# STORMWATER SITE PLAN

## Proposed Wesley Homes Puyallup Senior Living Project Phase II

Northwest Corner of 10th Street S.E.  
and 39th Avenue S.E.  
Puyallup, Washington

July 6, 2023  
Our Job No. 16718

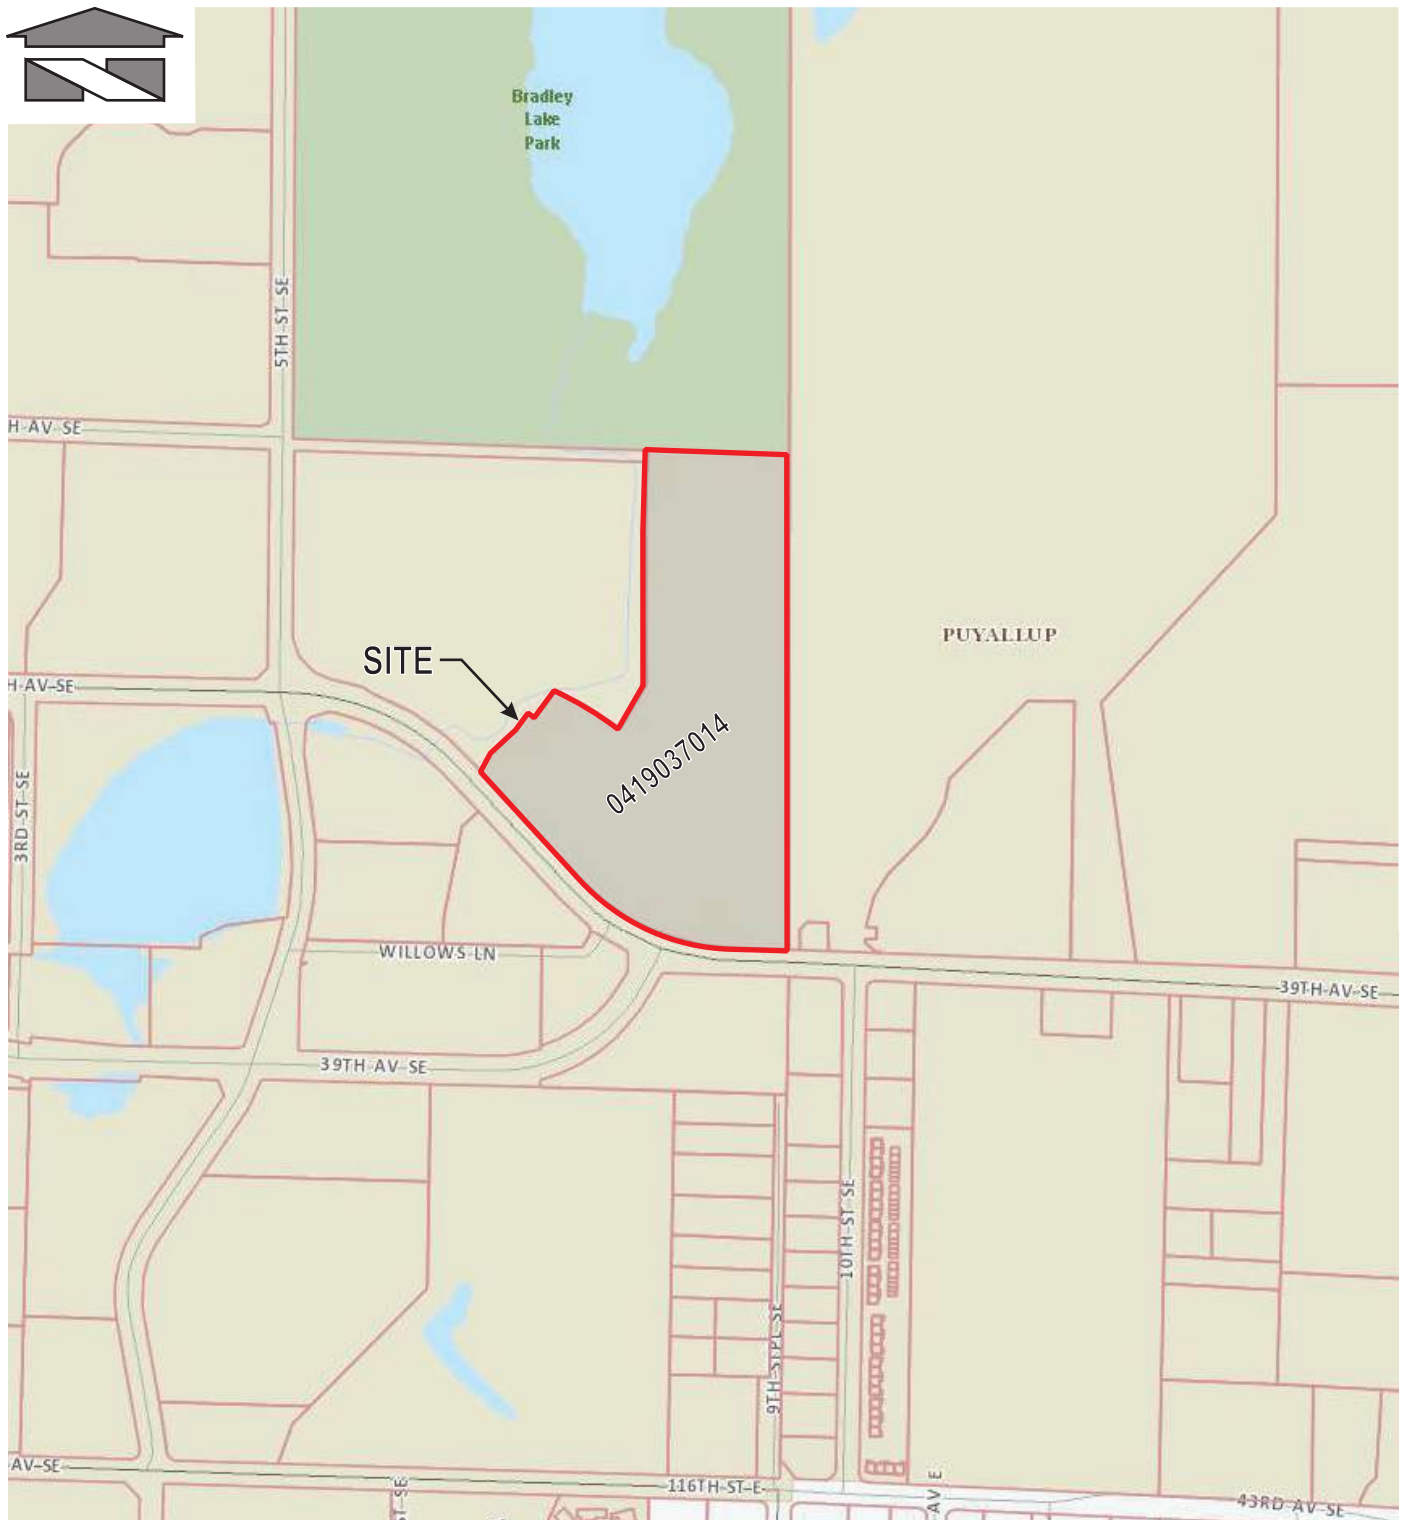
Per prior comment on the landuse application, clearly delineate the North and South basins on the basin map(s).  
[Storm Report; Pg 10 of 503]
